STATE OF NORTH CAROLINA
DEPARTMENT OF TRANSPORTATION

In reply, refer to
File No. SC-2004-084

MEMORANDUM

SUBJECT: Proposed Briar Chapel Development on US 15-501 at SR 1532 (Manns Chapel Rd.) and SR 1526/1528 (Andrews Store Rd.) in Chatham County.

Recommended Lanes and Storage Lengths for Briar Chapel

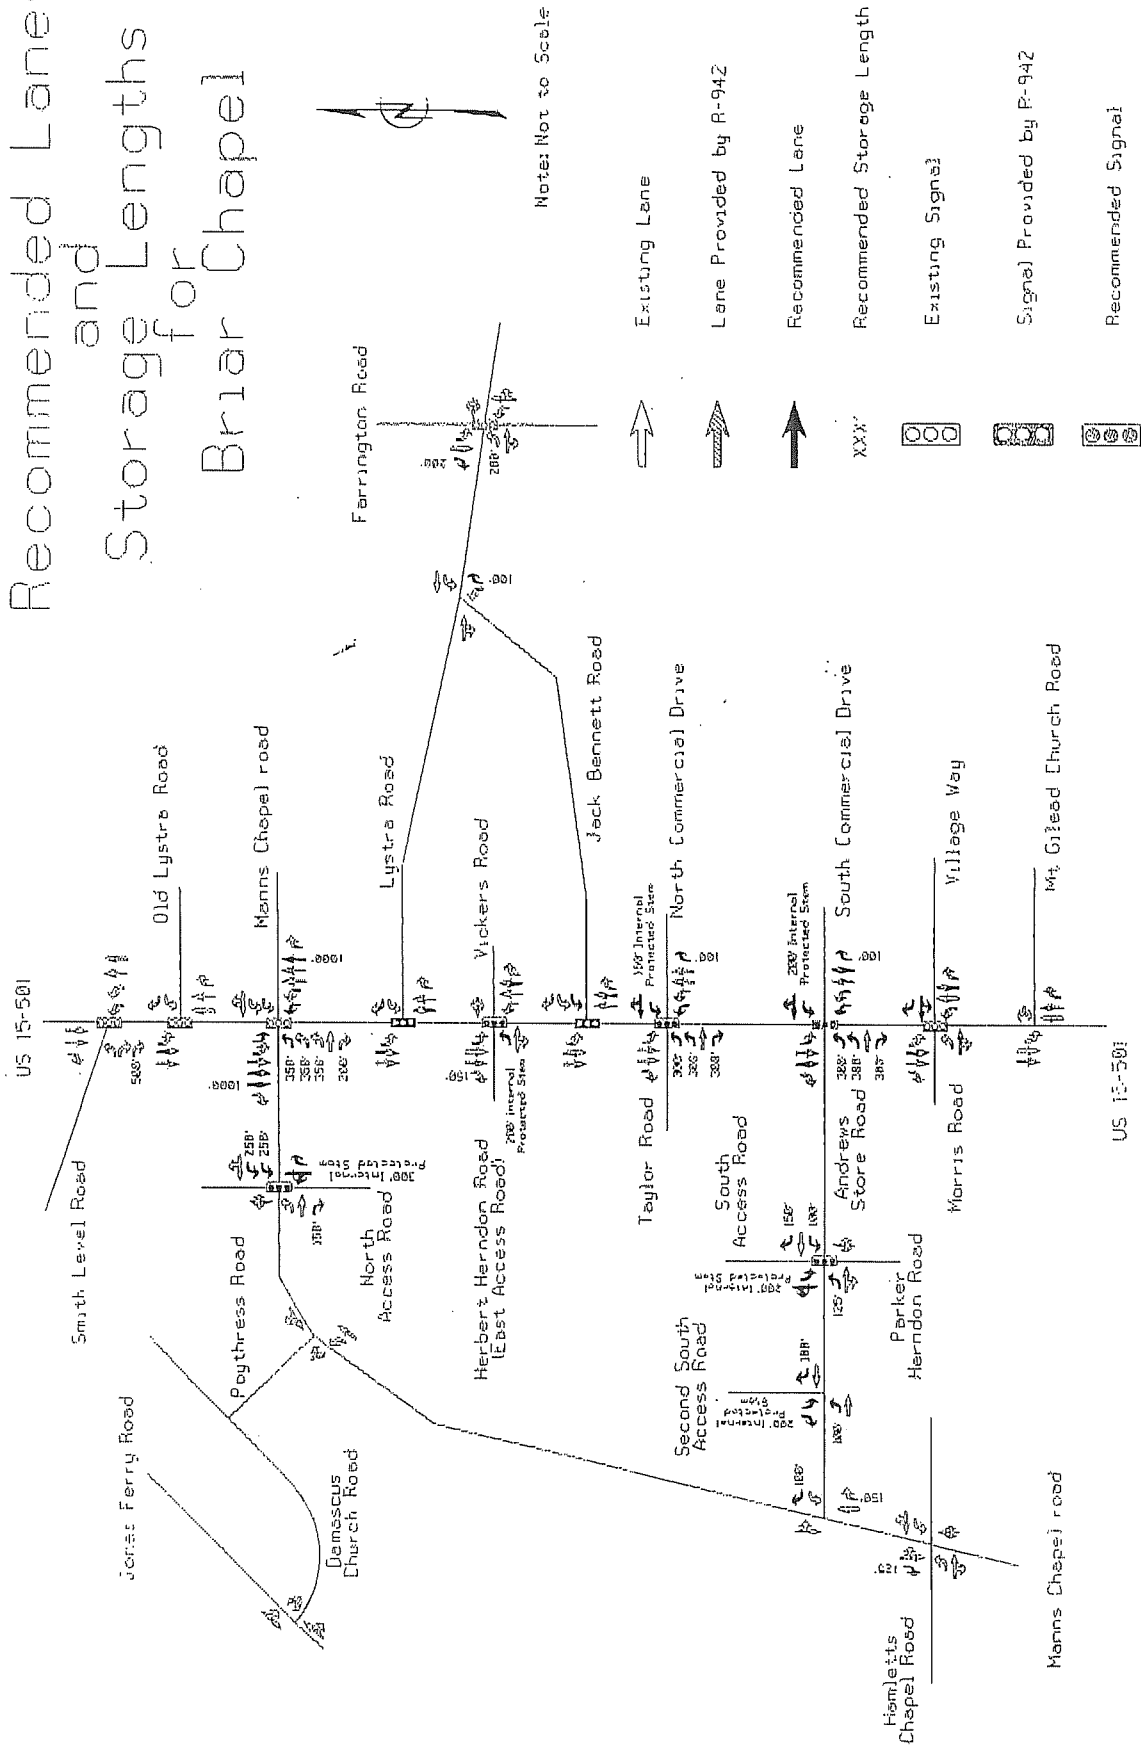
We recommend providing one (1) additional northbound and southbound through lane along US 15-501 at this intersection. The additional through lanes should commence a minimum of 1,000 feet prior to Manns Chapel Road and terminate a minimum of 1,200 feet beyond Manns Chapel Road.

- We recommend providing triple left-turn lanes with a minimum of 350 feet of full storage and appropriate transitional taper.
- We recommend extending the storage length for the exclusive right-turn lane to 200 feet (minimum) of full storage and appropriate deceleration taper.

- To accommodate the anticipated site-generated traffic volumes on this approach, we recommend providing dual left-turn lanes by constructing an additional left-turn lane. The full storage length should be equal to the storage provided by the TIP.
- Due to the additional left-turn lane for this approach, dual receiving lanes are necessary on the eastbound approach. We recommend providing 1,200 of receiving lane on the eastbound approach leg.
- We recommend maintaining an exclusive right-turn lane as provided by TIP Project R-942B.

- To accommodate the anticipated site-generated traffic volumes on this approach, we recommend providing dual left-turn lanes by constructing an additional left-turn lane. The full storage length should be equal to the storage provided by the TIP.

- We recommend providing a three (3) lane cross-section consisting of one (1) ingress and two (2) egress lanes with 200 feet (minimum) of internal protected storage before crossing maneuvers and parking should be allowed. The egress lanes should consist of an exclusive left-turn lane and a combination through/right-turn lane.

- We recommend extending the storage length for the exclusive right-turn lane to 150 feet (minimum) of full storage and appropriate deceleration taper.

- To accommodate the anticipated site-generated traffic volumes on this approach, we recommend providing dual left-turn lanes by constructing an additional left-turn lane. The full storage length should be equal to the storage provided by the TIP.

- We concur with the TIA recommendation of providing dual left-turn lanes; however, we recommend providing a minimum of 300 feet of storage and appropriate transitional taper.
- We recommend providing an exclusive right-turn lane with 300 feet (minimum) of full storage and appropriate deceleration taper.
- We recommend providing a concrete, monolithic island westward along Taylor Road for a minimum of 300 feet to provide protected storage.

- We concur with the TIA recommendation of providing a three (3) lane cross-section consisting of one (1) ingress and two (2) egress lanes; however, we recommend providing 150 feet (minimum) of internal protected storage before crossing maneuvers and parking should be allowed. The egress lanes should consist of an exclusive left-turn lane and a combination through/right-turn lane.

- To accommodate the anticipated site-generated traffic volumes on this approach, we recommend providing dual left-turn lanes by constructing an additional left-turn lane. The full storage length should be equal to the storage provided by the TIP.
- Due to the additional left-turn lane for this approach, dual receiving lanes are necessary on the eastbound approach. We recommend providing 1,200 of receiving lane on the eastbound approach leg.
- We concur with the TIA addendum recommendation of providing an exclusive right-turn lane with 100 feet (minimum) of full storage and appropriate deceleration taper.

- We recommend providing dual left-turn lanes with a minimum of 300 feet of storage and appropriate transitional taper.
- We recommend providing an exclusive right-turn lane with 300 feet (minimum) of full storage and appropriate deceleration taper.

- We concur with the TIA recommendation of providing a three (3) lane cross-section consisting of one (1) ingress and two (2) egress lanes; however, we recommend providing 200 feet (minimum) of internal protected storage before crossing maneuvers and parking should be allowed. The egress lanes should consist of an exclusive left-turn lane and a combination through/right-turn lane.

- To accommodate the anticipated site-generated traffic volumes on this approach, we recommend providing dual left-turn lanes by constructing an additional left-turn lane. The full storage length should be equal to the storage provided by the TIP.
- Due to the additional left-turn lane for this approach, dual receiving lanes are necessary on the eastbound approach. We recommend providing 1,200 of receiving lane on the eastbound approach leg.
- We concur with the TIA addendum recommendation of providing an exclusive right-turn lane with 100 feet (minimum) of full storage and appropriate deceleration taper.

- We recommend restriping the approach lanes to accommodate an exclusive right-turn lane and a combination through/left-turn lane. This configuration may require a realignment of this approach to align the through/left-turn lane with the opposing receiving lane on Morris Road.

- We recommend providing an exclusive right-turn lane with 150 feet (minimum) of full storage and appropriate deceleration taper.

- We recommend providing dual left-turn lanes with a minimum of 250 feet of storage and appropriate transitional taper.

- We recommend providing a four (4) lane cross-section consisting of two (2) ingress and two (2) egress lanes with 300 feet (minimum) of internal protected storage before crossing maneuvers and parking should be allowed. The egress lanes should consist of a combination through/left-turn lane and an exclusive right-turn lane.

- We concur with the TIA recommendation of providing an exclusive left-turn lane; however, we recommend providing 125 feet (minimum) of full storage and appropriate transitional taper.

- Due to the addition of an opposing left-turn lane on the eastbound approach and in an effort to provide sufficient site distances for the eastbound left-turn vehicles, we recommend providing an exclusive left-turn lane with 100 feet (minimum) of full storage and appropriate transitional taper.
- We recommend providing an exclusive right-turn lane with 150 feet (minimum) of full storage and appropriate deceleration taper.

- We concur with the TIA recommendation of providing a three (3) lane cross-section consisting of one (1) ingress and two (2) egress lanes; however, we recommend providing 200 feet (minimum) of internal protected storage before crossing maneuvers and parking should be allowed. The egress lanes should consist of an exclusive left-turn lane and a combination through/right-turn lane.

- We concur with the TIA recommendation of providing an exclusive left-turn lane; however, we recommend providing 100 feet (minimum) of full storage and appropriate transitional taper.

- We concur with the TIA recommendation of providing an exclusive right-turn lane; however, we recommend providing 100 feet (minimum) of full storage and appropriate deceleration taper.

- We concur with the TIA recommendation of providing a three (3) lane cross-section consisting of one (1) ingress and two (2) egress lanes; however, we recommend providing 200 feet (minimum) of internal protected storage before crossing maneuvers and parking should be allowed. The egress lanes should consist of an exclusive left-turn lane and an exclusive right-turn lane.

- We recommend providing an exclusive right-turn lane with 100 feet (minimum) of full storage and appropriate deceleration taper.

- We concur with the TIA recommendation to extend the exclusive right-turn lane storage to provide 150 feet of full storage and appropriate deceleration taper.

- We recommend providing an exclusive right-turn lane with 125 feet (minimum) of full storage and appropriate deceleration taper.

- We recommend providing an exclusive right-turn lane with 100 feet (minimum) of full storage and appropriate deceleration taper.

- We recommend extending the existing storage length for the exclusive left-turn lane to 200 feet (minimum) of full storage and appropriate transitional taper.

- We recommend providing an exclusive right-turn lane with 200 feet (minimum) of full storage and appropriate deceleration taper.
